**SUBJECT: Wireless Telecommunications Facility Permit Application
(T-Mobile Site # LA33664E)**

SECOND NOTICE OF INCOMPLETENESS

Subject: Second Screencheck Comments - Wireless Telecommunication Facility Permit T-Mobile Site #LA33664E; W/O 10876 Culver Blvd

**ATTACHMENT 1
SECOND SCREENCHECK COMMENTS
WIRELESS TELECOMMUNICATION FACILITY PERMIT
T-MOBILE SITE #LA33664E – W/O 10876 CULVER BLVD**

SHEET TITLE:
SITE PLAN
AND DETAILS
SHEET NUMBER:
A-1

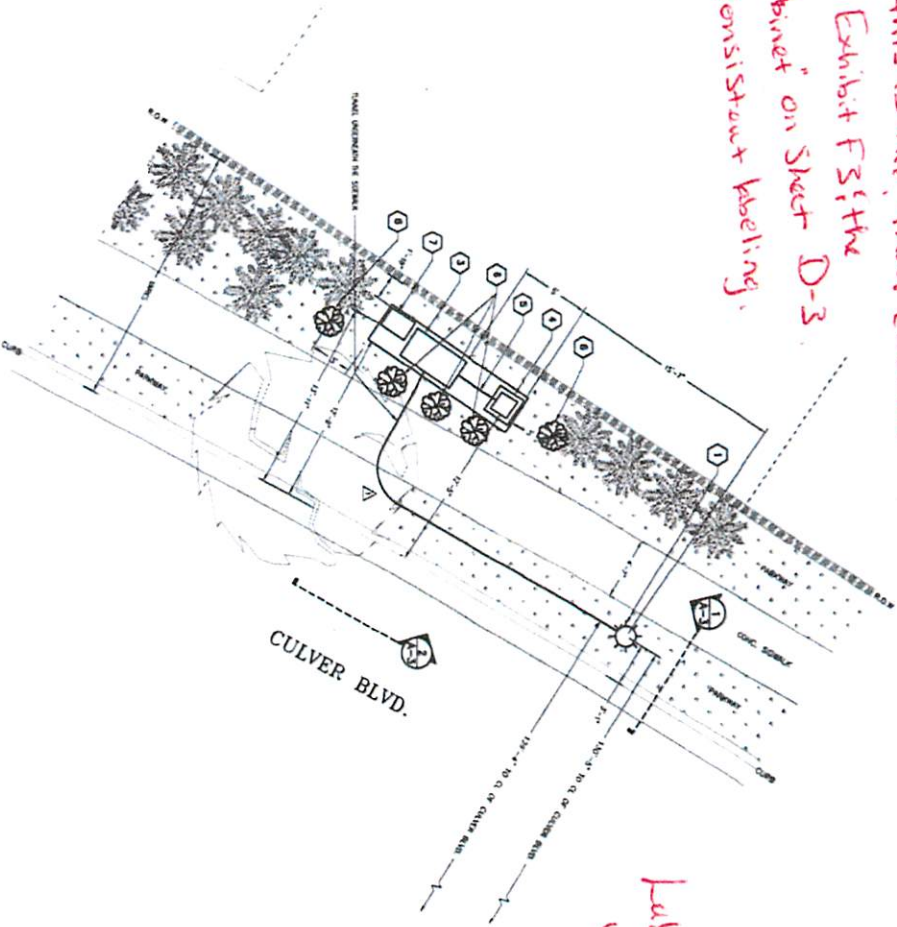
16. *2nd Request.* Label surrounding buildings and land uses. See redlined plans.

17. Show setback dimensions from the ground equipment to the nearest residential property and from the new pole to the nearest residential property. See redlined plans.

Dimension distance
from equipment to nearest residential
property & from new pole to nearest
residential property.

Label uses?
Residential?

Label use

SHEET TITLE:
SITE PLAN
AND DETAILS
SHEET NUMBER:
A-2

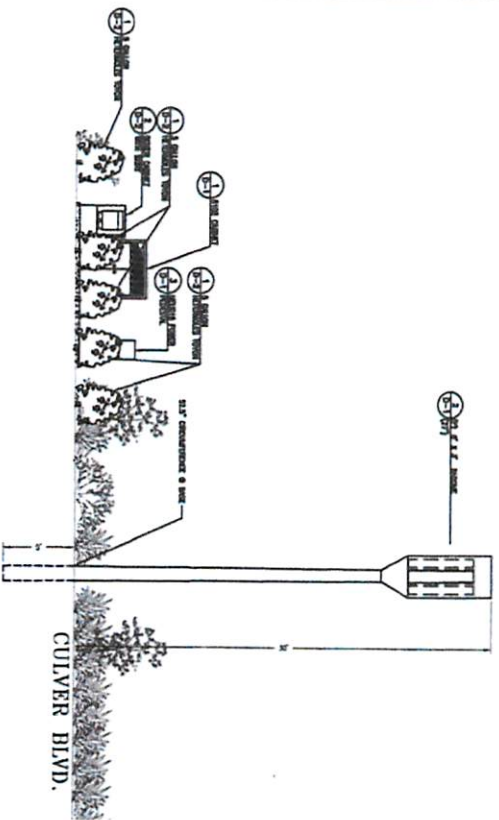
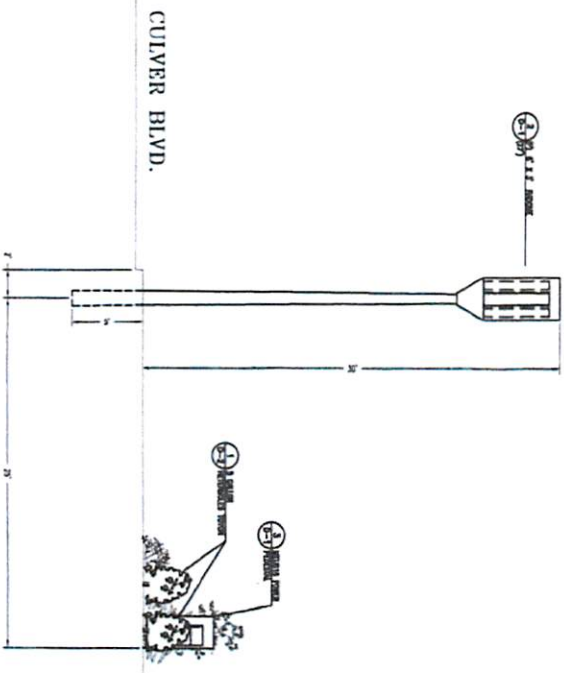
18. Label all existing utilities. See redlined plans.

19. Clarify if note #7 in the Placement and Construction Data section is referring to the same equipment as that which is referred to as the “fiber cabinet” shown on Exhibit F3 and the “boxer cabinet” shown on Sheet D-3 of the engineering plans. If so, provide consistent labeling in all exhibits.

Clarify if this is the "fiber cabinet" labeled in Exhibit F3; the "Boxer cabinet" on Sheet D-3. Provide consistent labeling.

Label any existing utilities.

D-3

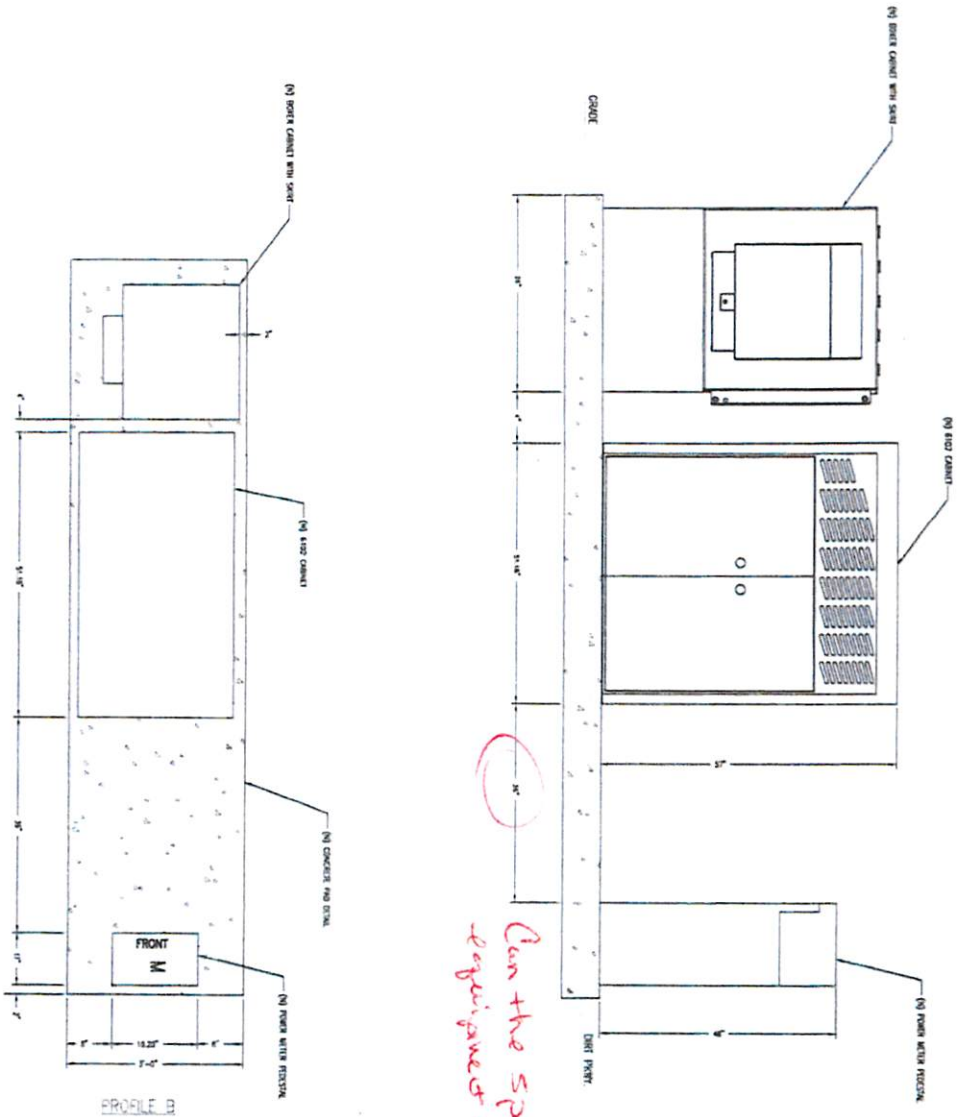
23. *2nd Request.* Decrease the size of the concrete pad to minimize the impact to the landscaped parkway. Provide clarification on why there needs to be so much space between the cabinet and the meter pedestal. See redlined plans.

Can the space between
equipment be minimized?
